To: T10 SAS Protocol and Phy Working Groups

From: Brian Day and William Petty

Subject: SAS-2.1 / SPL: 08-439 An Optical OOB Method

Overview

Figure 1 — OOB signal transmission

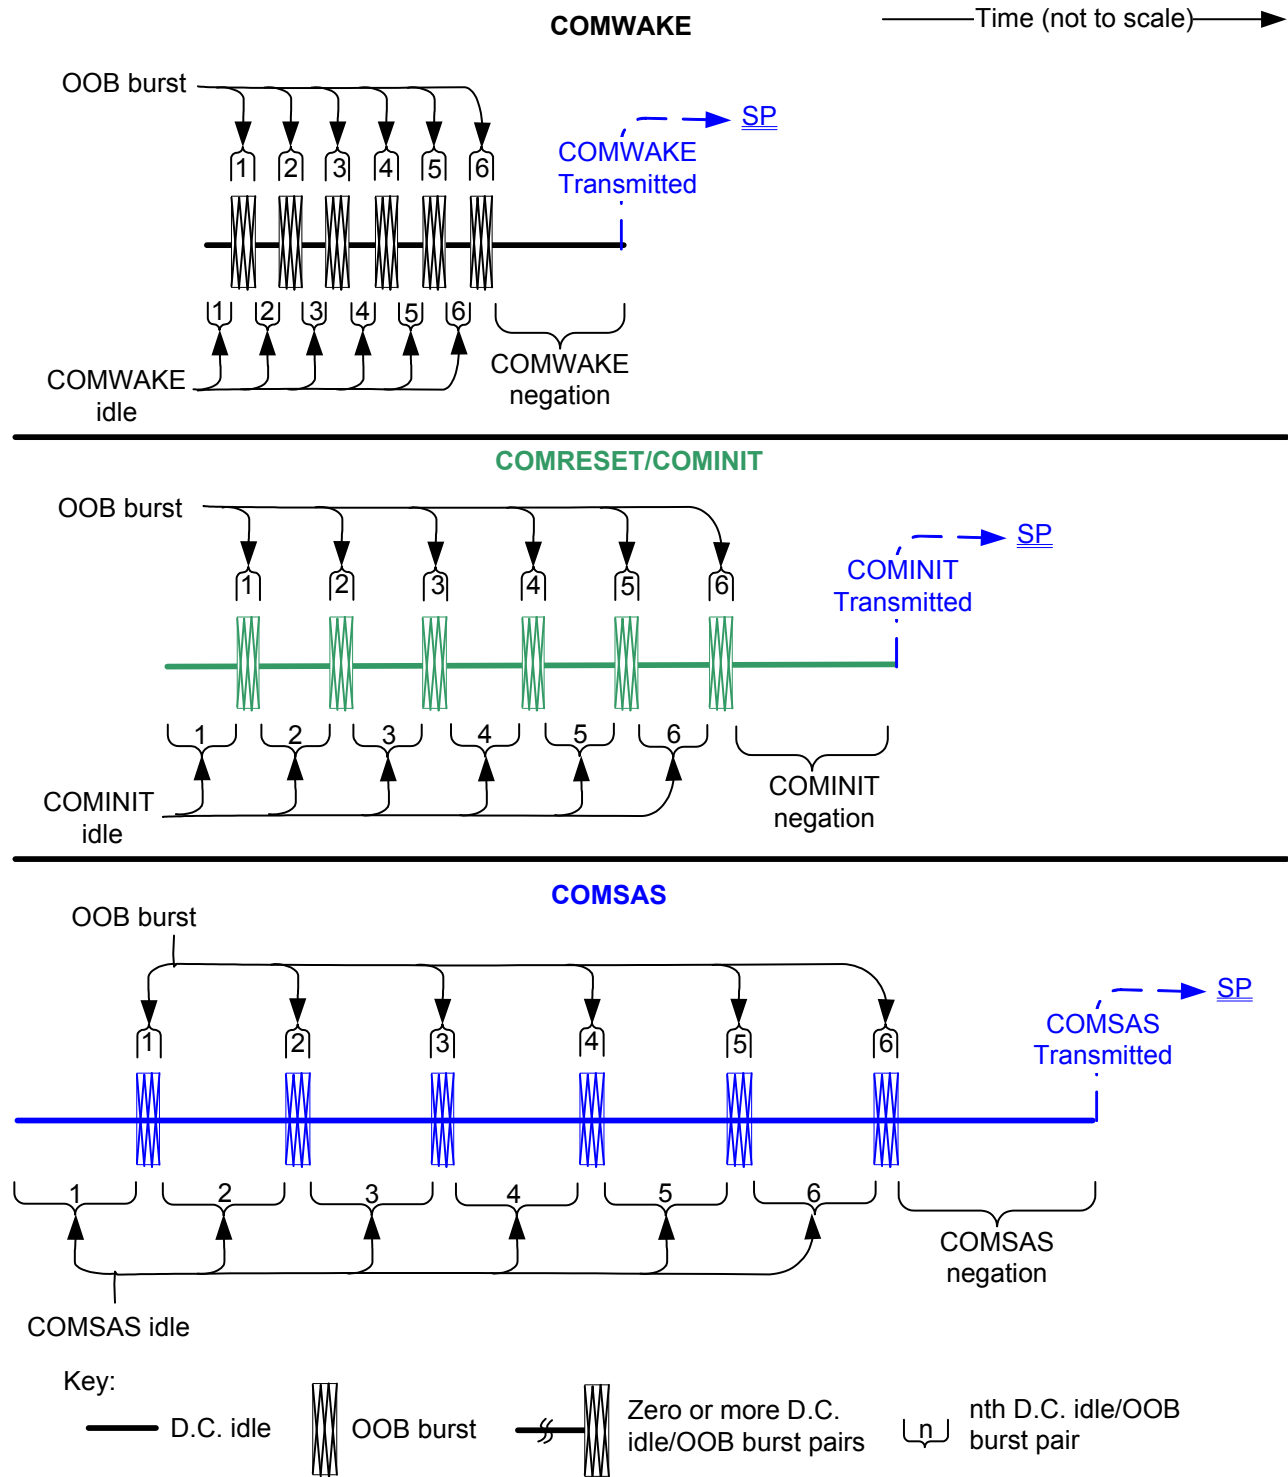
Editor's Note 1: [All figures in section 6 need to replace "D.C. Idle" with "OOB Idle"](#).

Note: D.C. idle is shown here as a neutral signal for visual clarity only.

Figure 2 — OOB signal detection

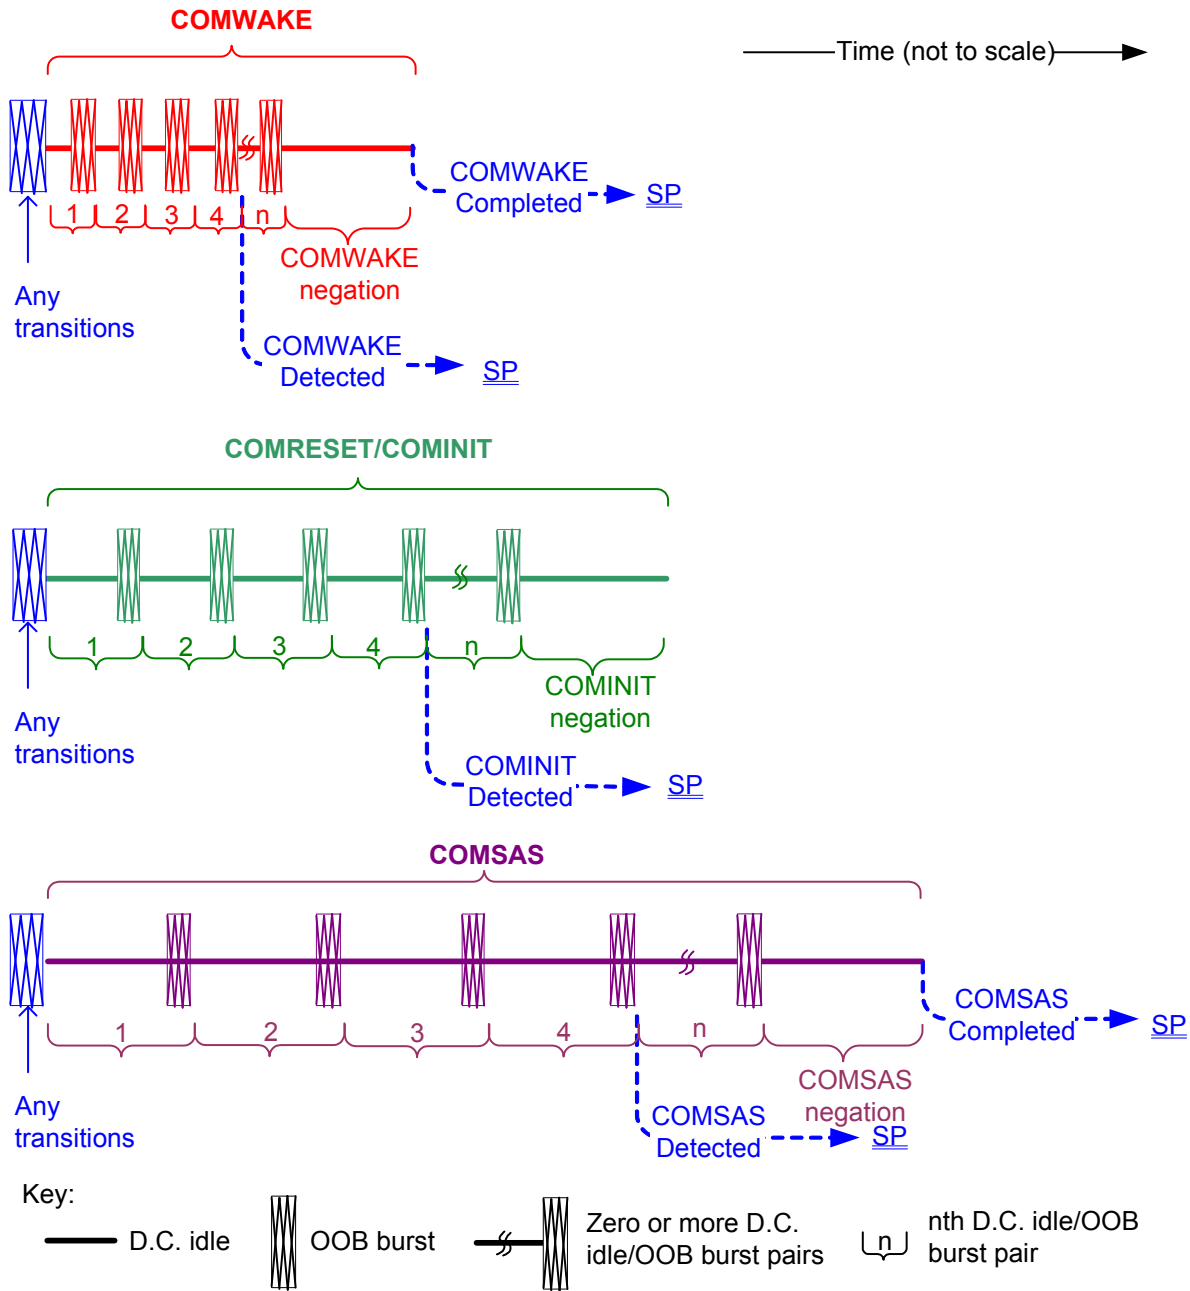
Editor's Note 2: Throughout section 6.7 and 6.8, replace all references of "D.C. idle" with "OOB idle" for the idle times to transmit OOB signals. Change all references of "D.C. idle" with "negation idle" for the idle time during the speed negotiation window during the RCdT.
